# Service Kit 753-0864

CODE: PE-118

SUBJECT: 42-inch Deck Bagger Hooks  
& Extension Tube

Figure 1

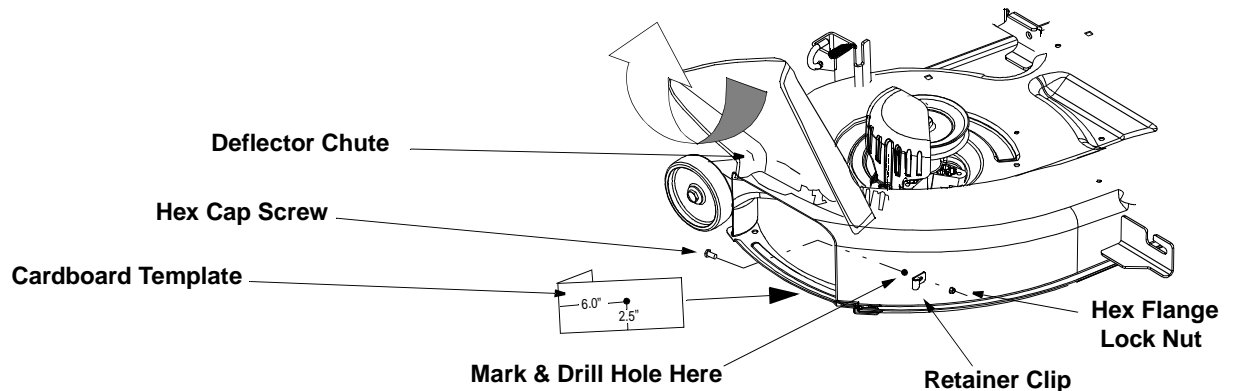
- Use this kit in the event that the discharge chute fails to remain in place when the operator raises and lowers the cutting deck while bagging or in the event that the cover assembly fails to remain in the open (up) position while the operator attempts to remove and empty the grass bags.

1. Crease the template included in this kit and place it over the front of the cutting deck near the discharge area as illustrated in Figure 1. Mark the hole location on the cutting deck with a center punch.
2. Remove the template and with a 1/4" bit, drill a hole on the mark made with the center punch.

3. Attach the retainer hook bracket to the cutting deck using the hex cap screw and hex flange lock nut included in this kit. See Figure 1.
4. Attach the extension tube included in this kit to the top of the bagger discharge chute. Secure it in place by attaching the retainer straps to the retainer clips found on the chute tube. See Figure 2.
